PG&E Letter DCL-15-095

Diablo Canyon Units 1 and 2

Response to NRC Request for Additional Information Regarding Recommendation 2.1
of the Near-Term Task Force Seismic Hazard and Screening Report

Response to NRC Request for Additional Information Regarding Seismic Hazard and Screening Report

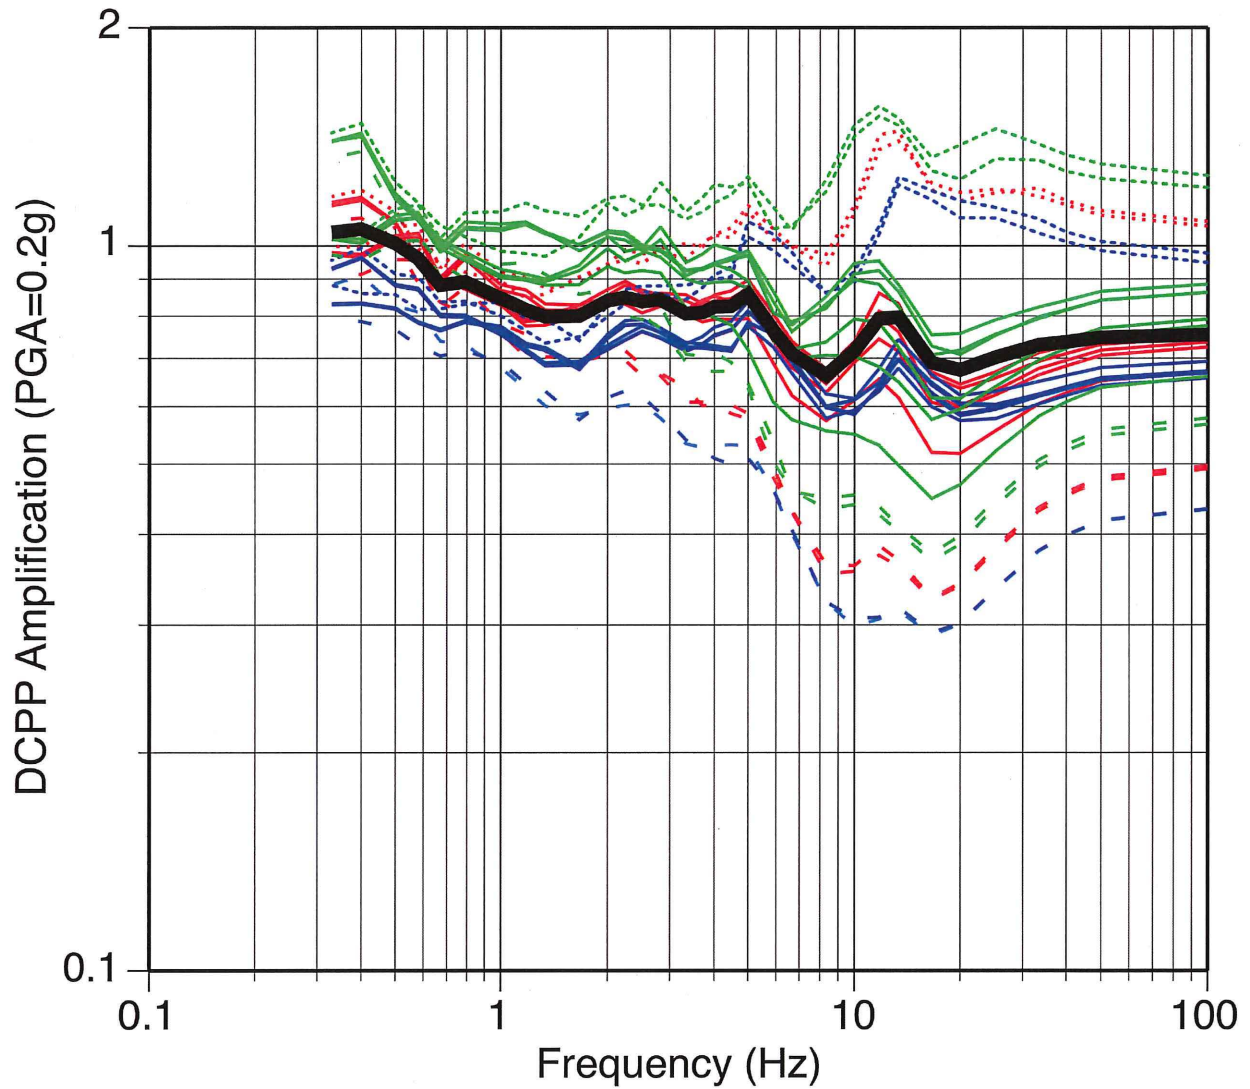
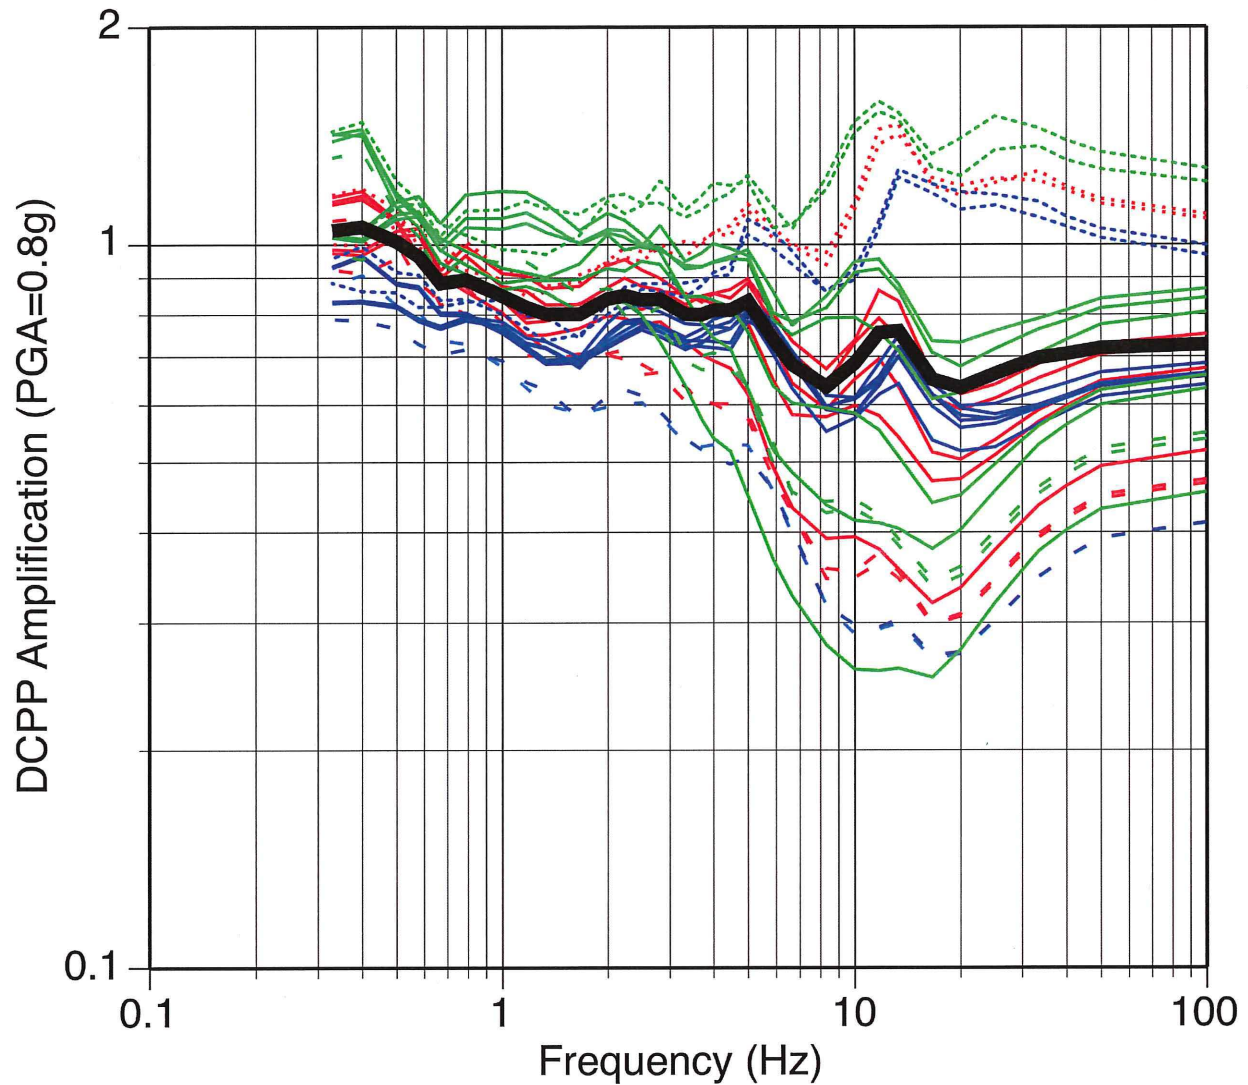
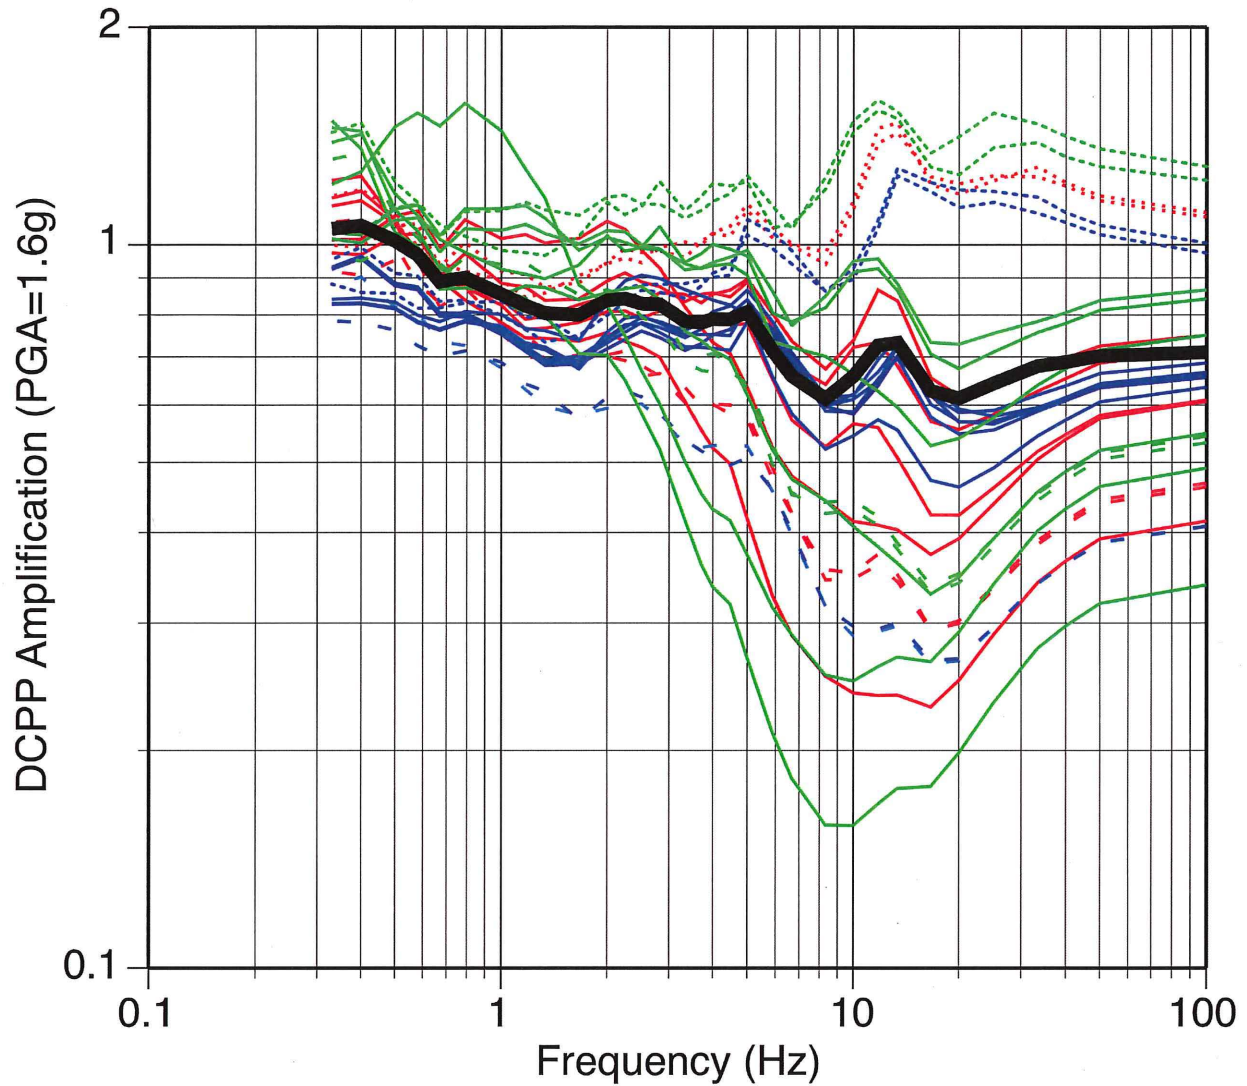
In addition, provide the adjustment factors (VS-kappa corrections) needed to modify the median ground motion models for the selected reference or baserock elevation and velocity. Also include in the response, as a figure and a table, control point seismic hazard curves developed using the site amplification factors and their uncertainties through the hazard integral as recommended in Appendix B of the SPID.

Using the material properties described in the response to NRC Question 1, the amplification factors (VS-kappa corrections) for the median ground motion are shown in Figures 4-1, 4-2, and 4-3 for reference rock PGA values of 0.2g, 0.8g, and 1.6g, respectively. The group of larger amplification factors at high frequencies is associated with the lower kappa value of 0.024 sec.
